New Albany Board of Zoning Appeals
March 23, 2026, Meeting Minutes – DRAFT

**Architectural Review Board Staff Report
April 13, 2026 Meeting**

**POLICE TRAINING FACILITY
CERTIFICATE OF APPROPRIATENESS AND WAIVER**

LOCATION: 7420 Walnut Street (PID: 222-004741)
REQUEST: Certificate of Appropriateness
ZONING: Agricultural District (AG) to Community Facilities (CF)
STRATEGIC PLAN: Residential
APPLICATION: ARB-06-2026
APPLICANT: City of New Albany c/o EMH&T

Image: proposed location of storage structure (blue circle) and press box (red circle).

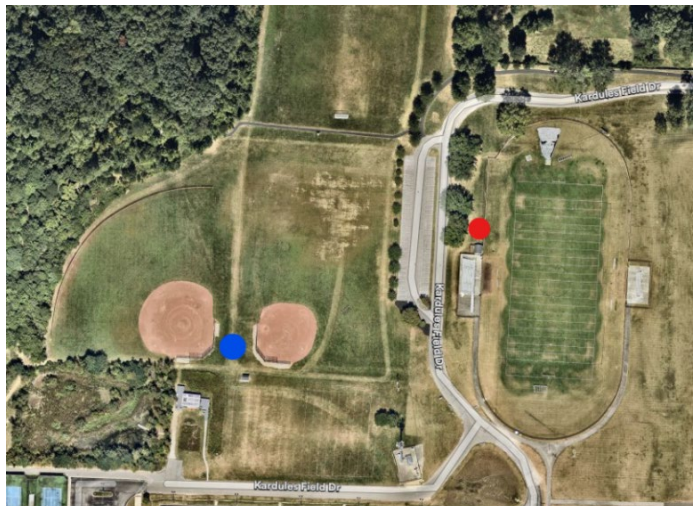
- The press box will be relocated on the north side of the existing bleachers on 6666 McElwee Drive. It stands at approximately 21.5 feet in height with a staircase on one side to provide pedestrian access to the second story.
- The press box has exterior downcast lighting over the entrances on the first and second stories.
- The storage structure will serve the two softball fields.
- While there is little to no screening of the structures from the public right-of-way along New Albany-Condit Road, because of the large setback from the road and a noticeable grade change, the structures are functionally screened from view.

- The existing press box includes signage on two of its faces. The signage was not part of the approval for the press box in 2019. Staff recommends a condition of approval that the signage be removed from the press box or the applicant return to the Architectural Review Board for a certificate of appropriateness for the signage (condition #1). A certificate of appropriateness may be requested separately for the signage to be reinstalled.
